STP-8042(6)

EASTERN CONNECTOR FROM
BUENA VISTA ROAD TO MACON ROAD/SR 22

P. I. No. 350850
Muscogee County, Georgia

Value Engineering Study Report

DESCRIPTION: **INCREASE RADIUS OF EASTERN CONNECTOR CURVE NO. 7004 AT THE WEST CENTRAL GEORGIA REGIONAL HOSPITAL** SHEET NO.: **1 of 4**

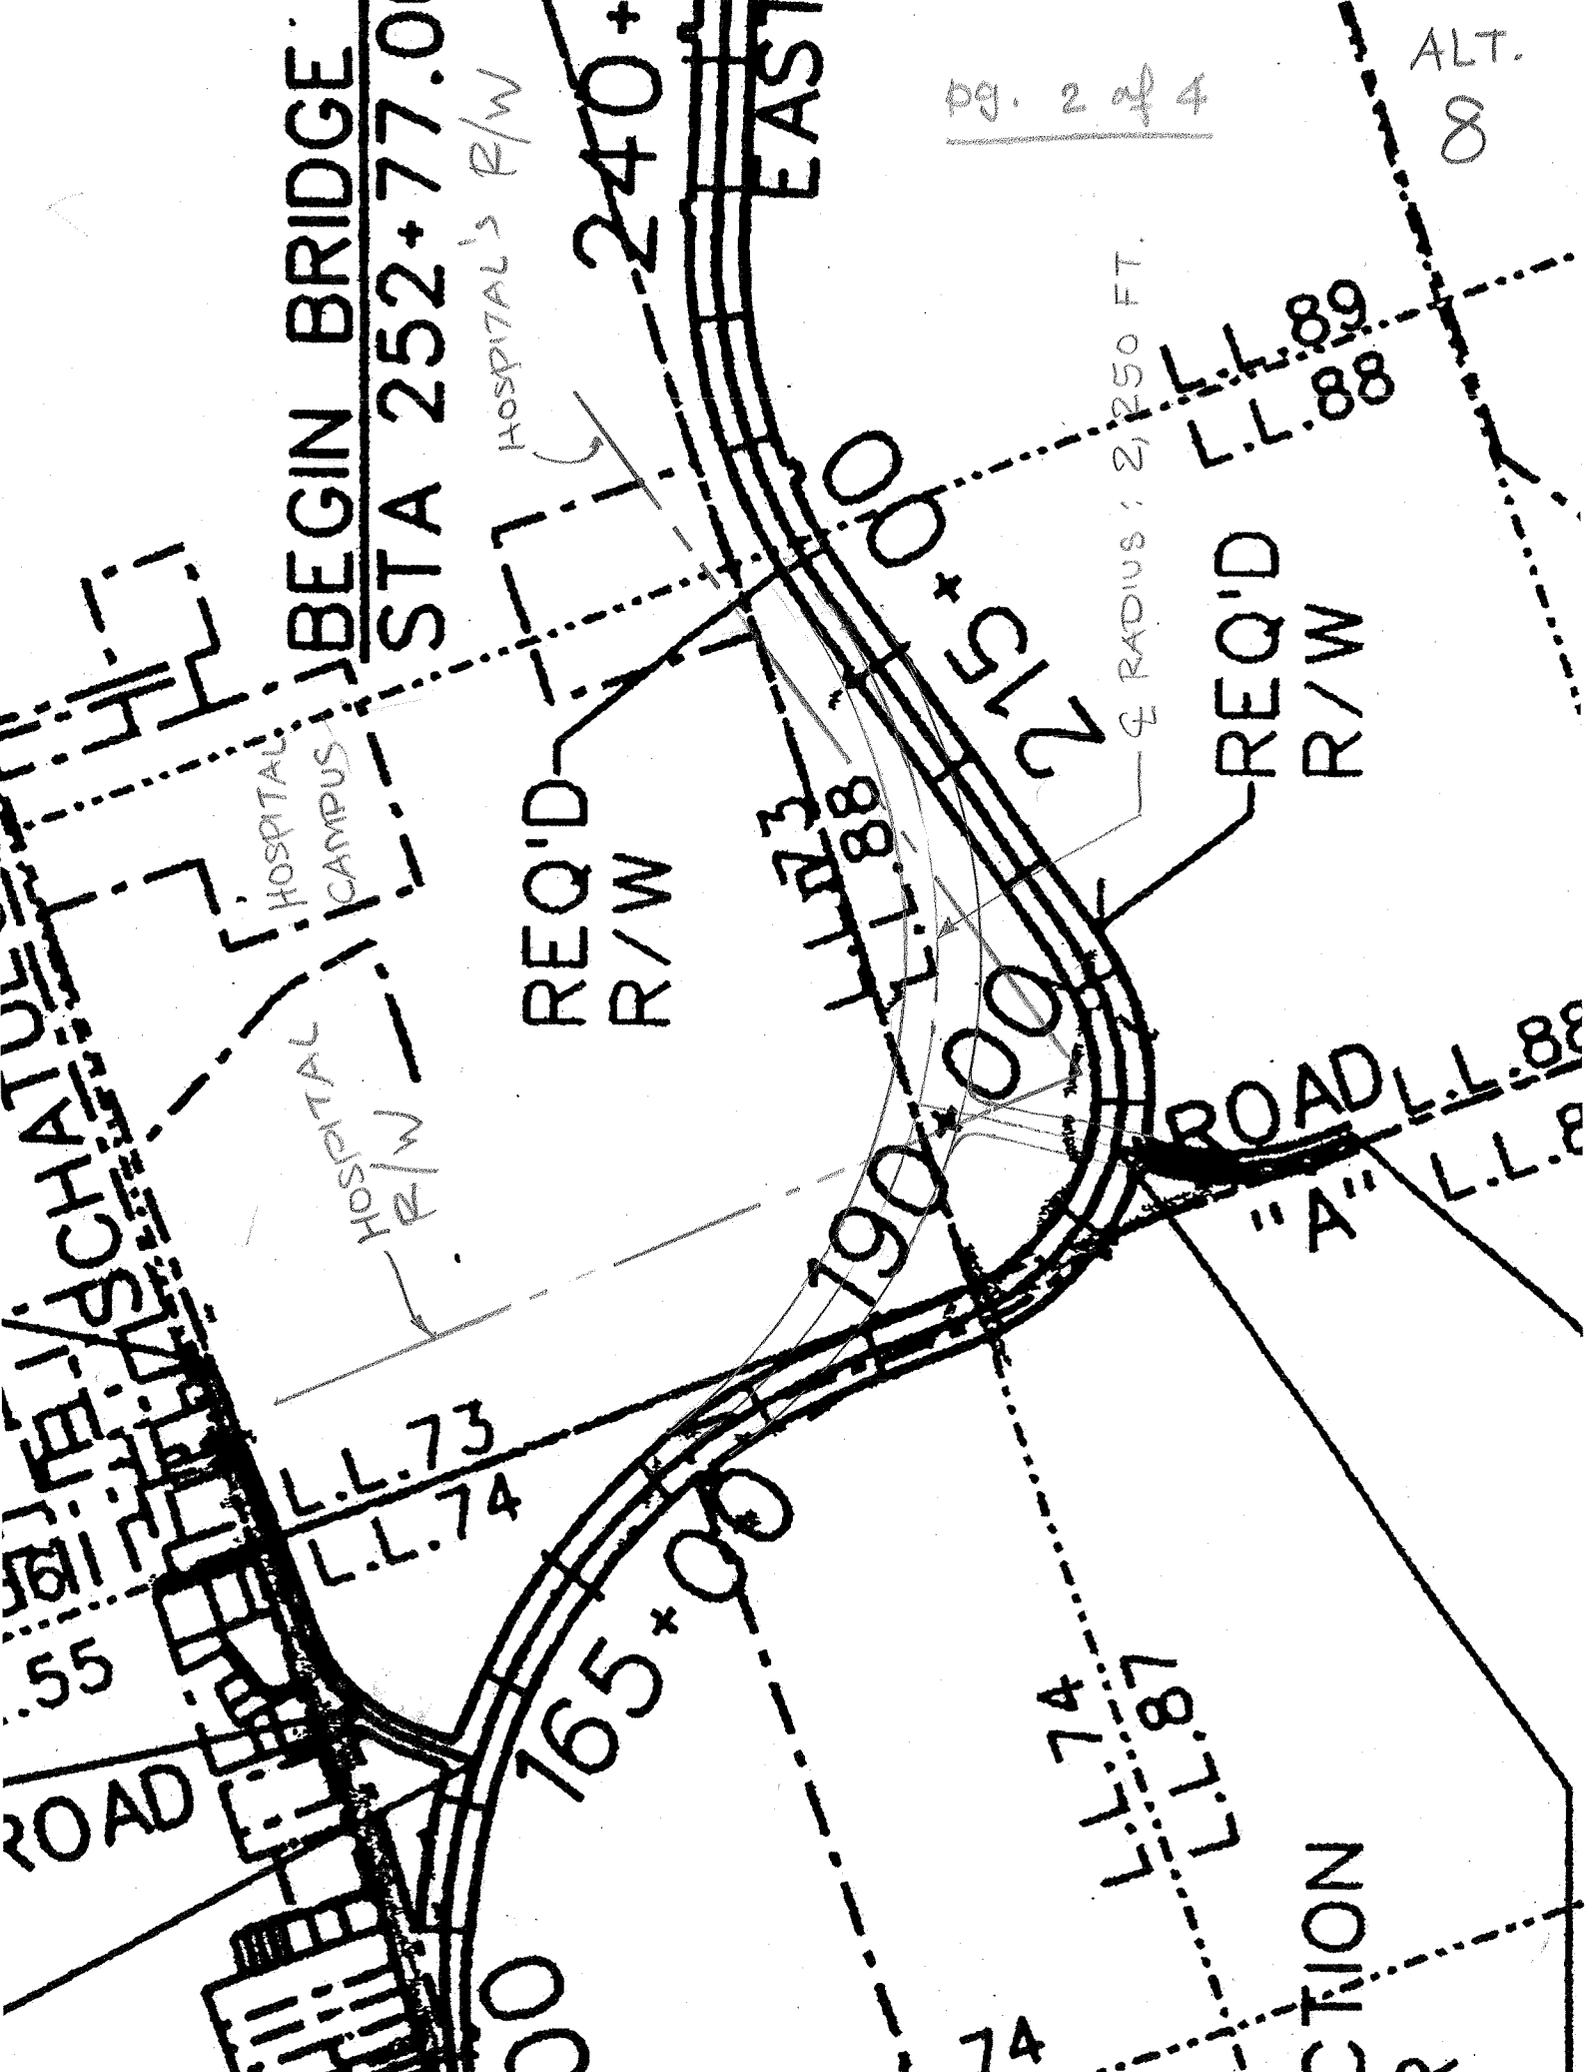
Increase Curve No. 7004's radius to 2,250 feet to flatten the curve and provide a smoother transit through this portion of the Eastern Connector.

The proposed change calls for the reverse curve to commence at STA 179+69.37 and run for a length of 3,000 feet. Alternately, the curve could begin at STA 170+00, have a tangent of 1,000 feet and let the curve begin at STA 180+00. The curve would then end at STA 210+00—a new station which would be STA 215+00 in the original design. This results in approximately 800 feet of pavement savings for the Eastern Connector.

Nearly seven acres of hospital property would be required to accommodate this alternative.

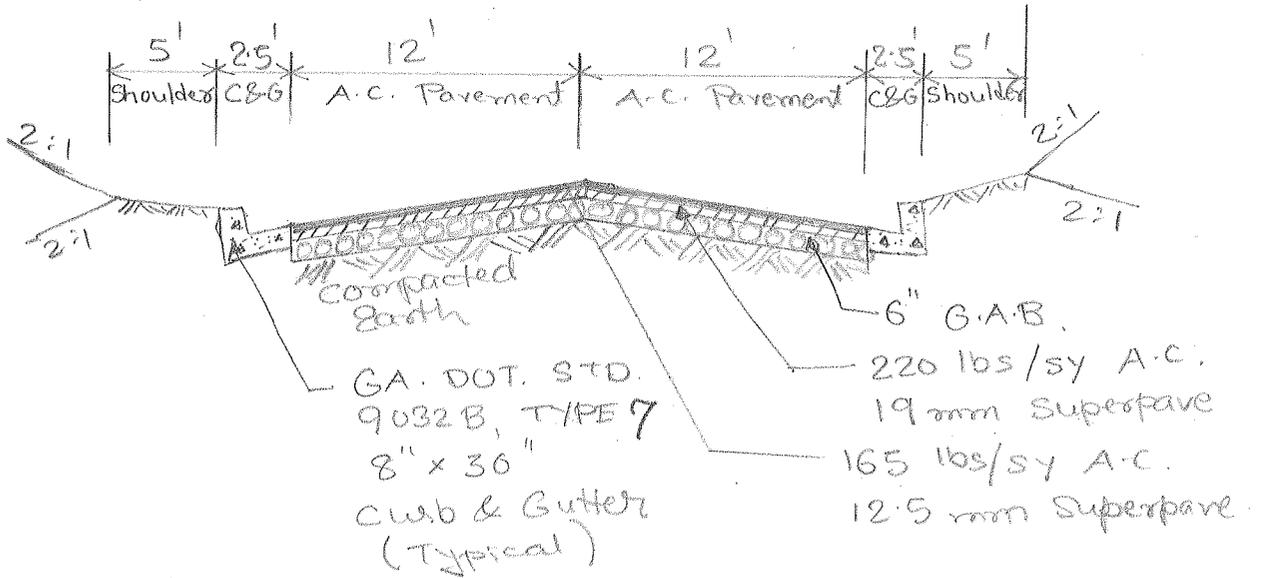
Provide a new 24-foot wide asphalt concrete pavement roadway with 5-foot shoulders and 30-inch curb and gutters on both sides to access West Central Georgia Regional Hospital.

Under the current situation, access to the West Central Georgia Regional Hospital is only from Shaltuga Road. Due to the anticipated office/industrial development along the Eastern Connector, it may be prudent to provide for additional access to the hospital from the new facility. This new street is not intended as a thoroughfare but merely as access to the hospital proper, perhaps only for emergency vehicles.

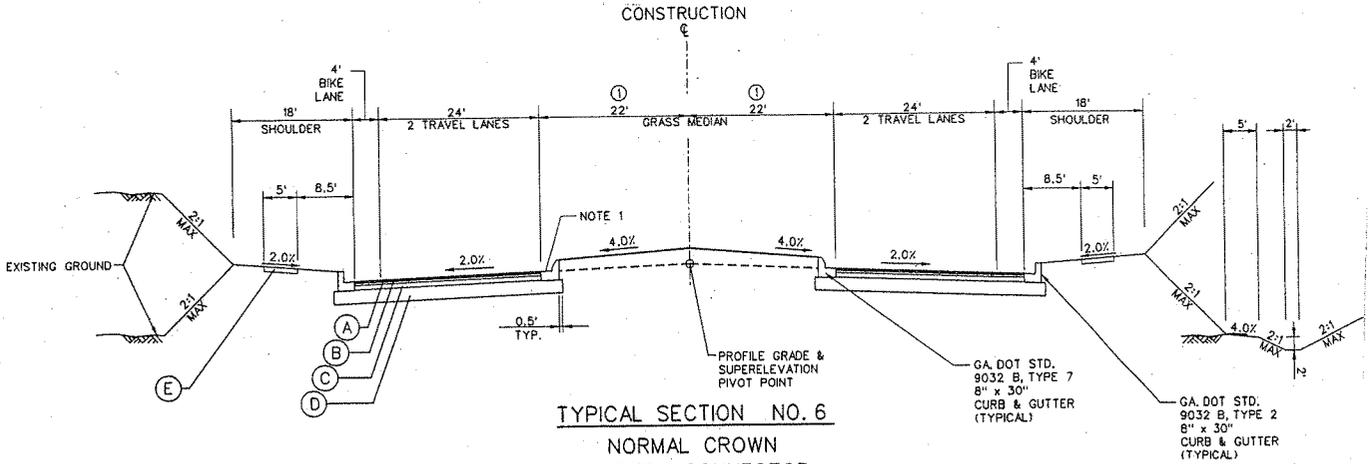
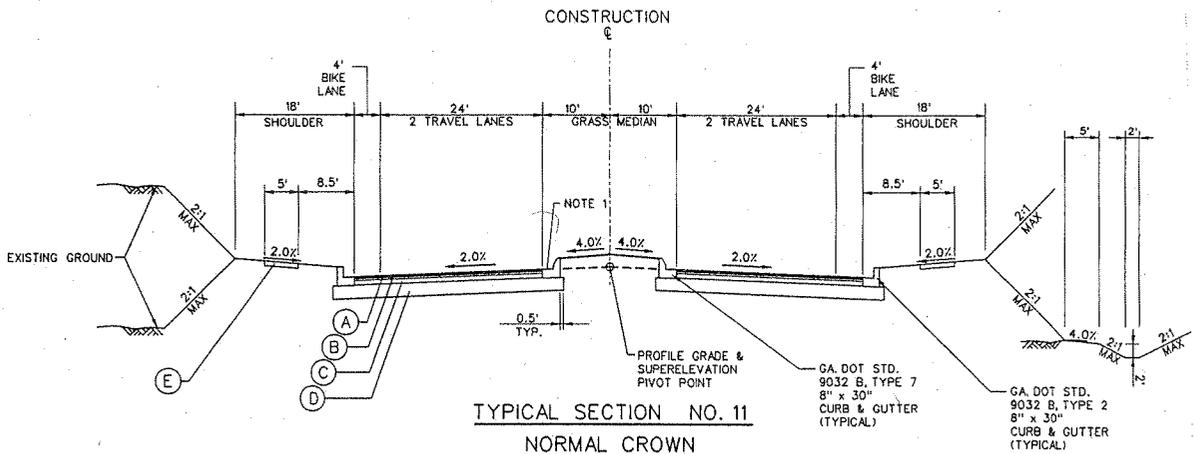
It is noted this alternative does not change that portion of the Eastern Connector already constructed to the 44-foot raised median criteria.

From: 146+50 (No. 7)
 (TRANSITION TO 151+00)

To: 375+88 (No. 7)
 (TRANSITION TO: 381+50)
 309+00 → BUILT ALREADY

DESCRIPTION: **RECONFIGURE THE RAMP FROM SR 22 SPUR TO US 80/MACON ROAD EASTBOUND** SHEET NO.: **1 of 4**

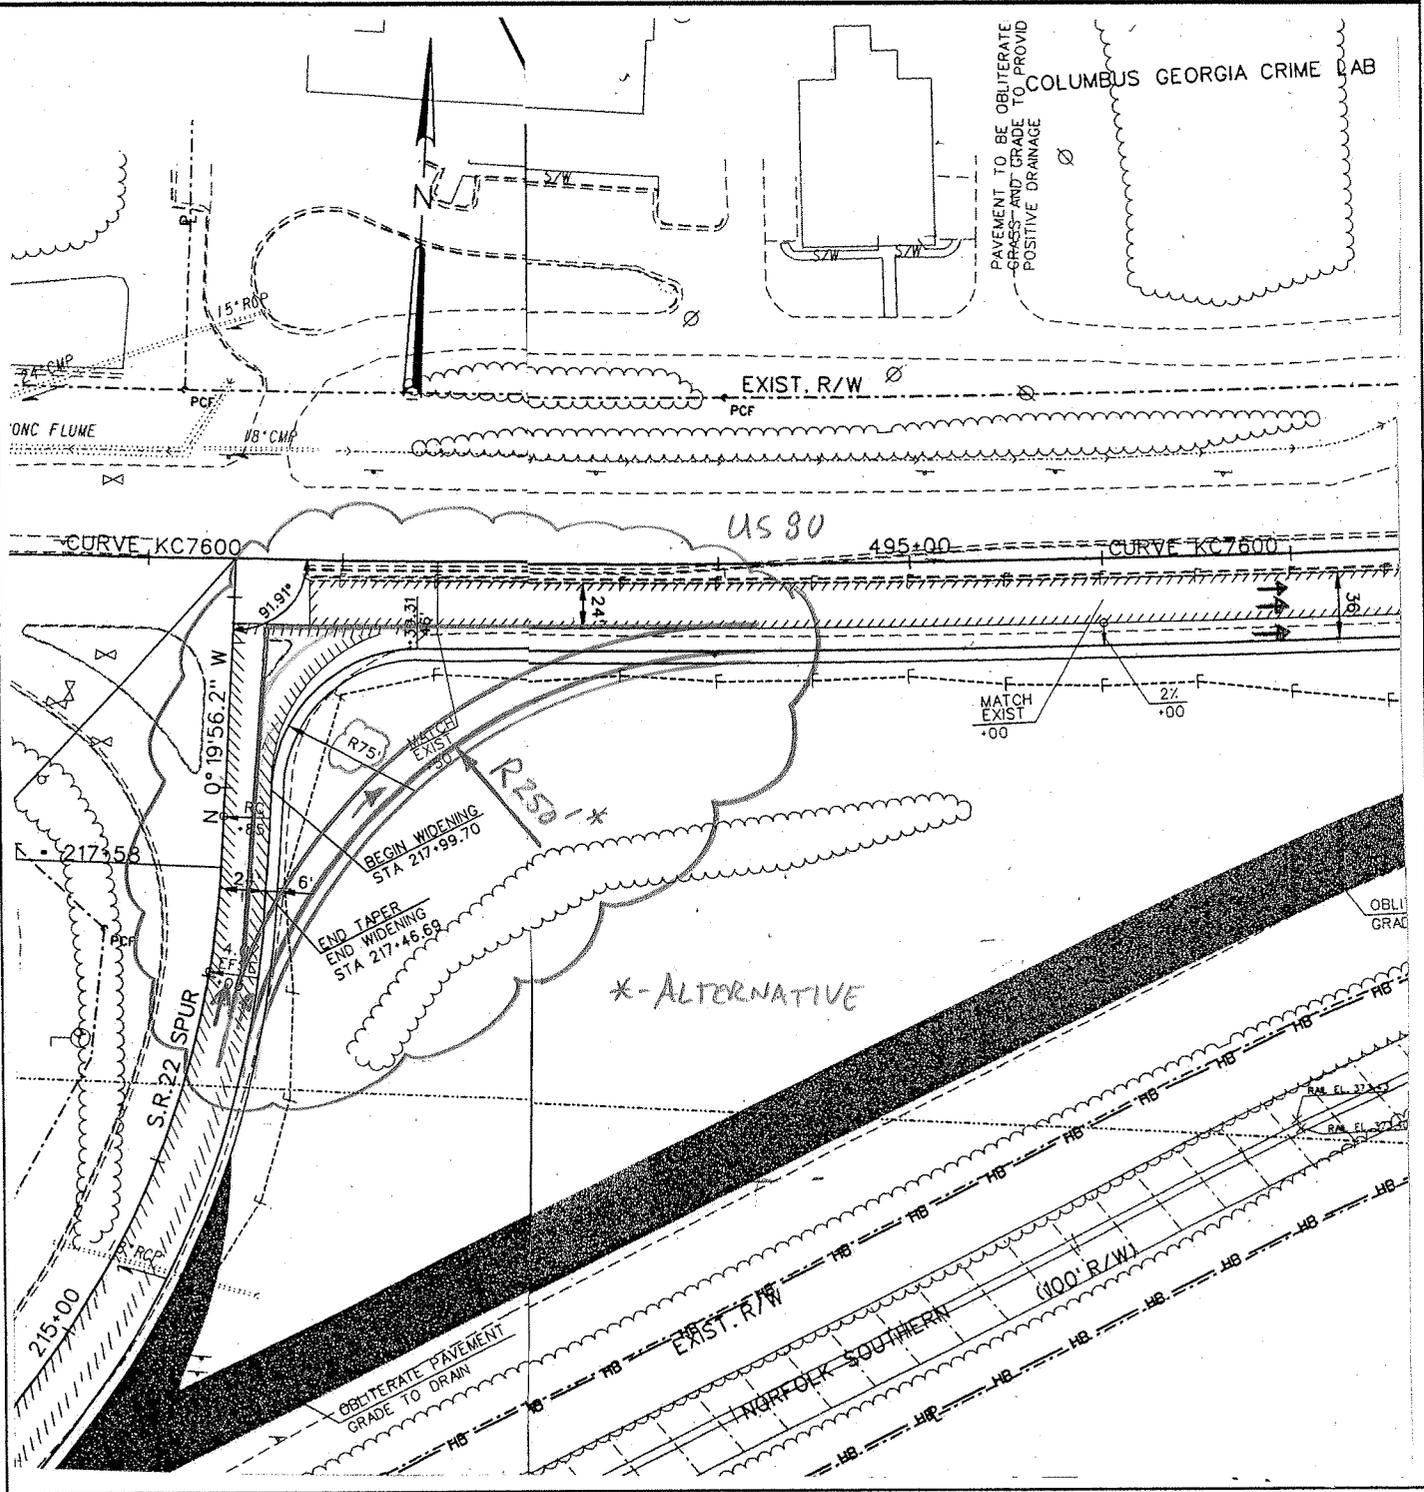
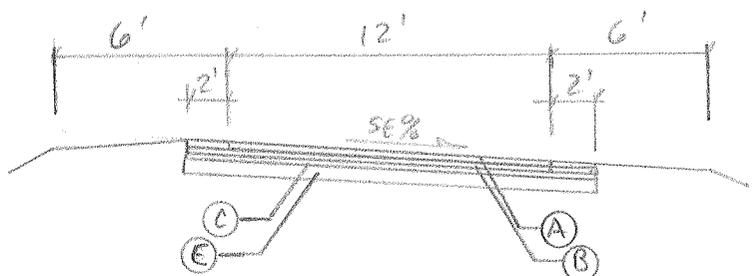
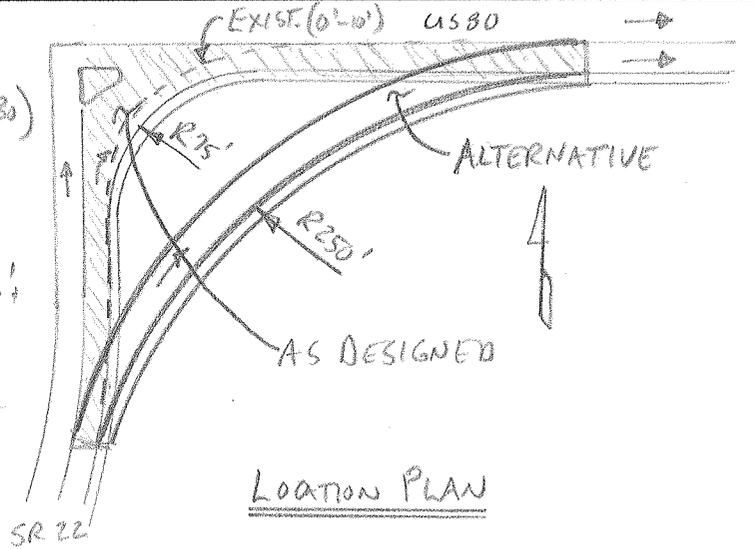
The traffic design hourly vehicle (DHV) is 250 (300) for this ramp. The current layout will require traffic to slow considerably and stop at congested periods. The increased radius will allow traffic to maintain higher speed for better flow and possible lane changing on US 80/Macon Road. This alternative will shorten the dedicated lane slightly while eliminating the hazardous acceleration zone of the current layout.

* NO PROFILE DATA AVAILABLE

AREA AS DESIGNED: (TYP. SECT. NO. 30)

DESCRIPTION: **USE PREFABRICATED ARCH SPAN STRUCTURES IN LIEU OF MULTI-CELL CONCRETE BOX CULVERTS** SHEET NO.: **1 of 4**

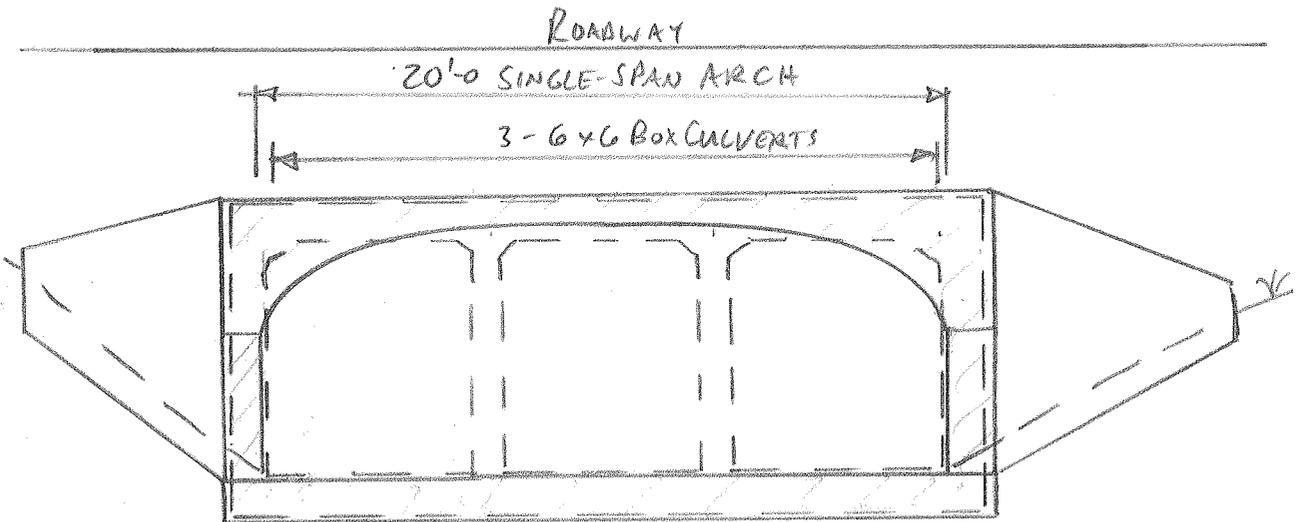
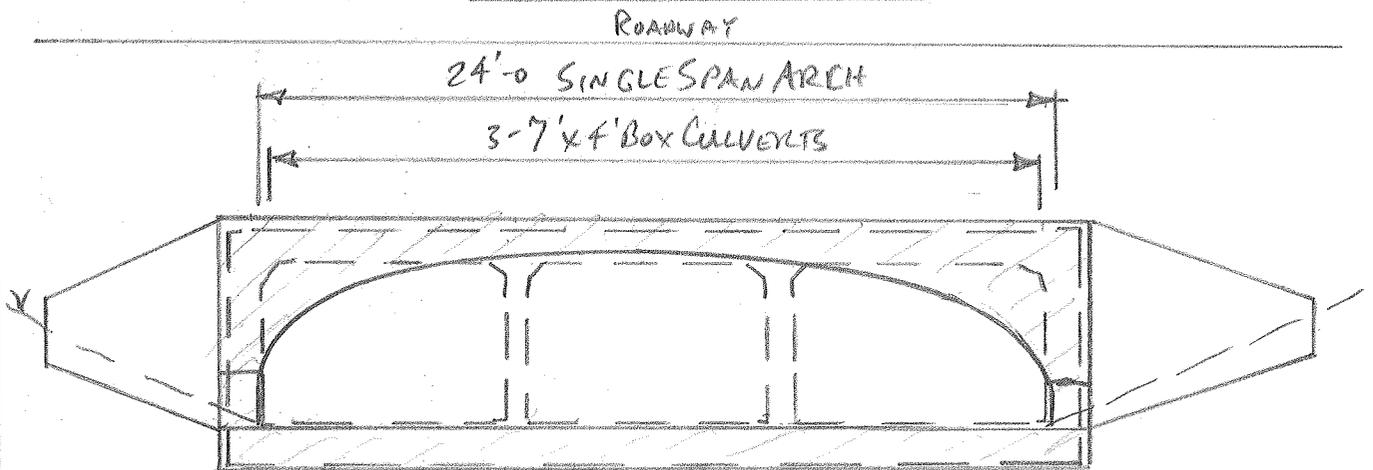
The structures are below the 100-year high-water elevation. Removing mid-stream obstructions will improve the stream flow and potentially help avoid flooding. Furthermore, the maintenance associated with debris removal is minimized.

TYPICAL SECTION @ STREAM #7

TYPICAL SECTION @ STREAM #8
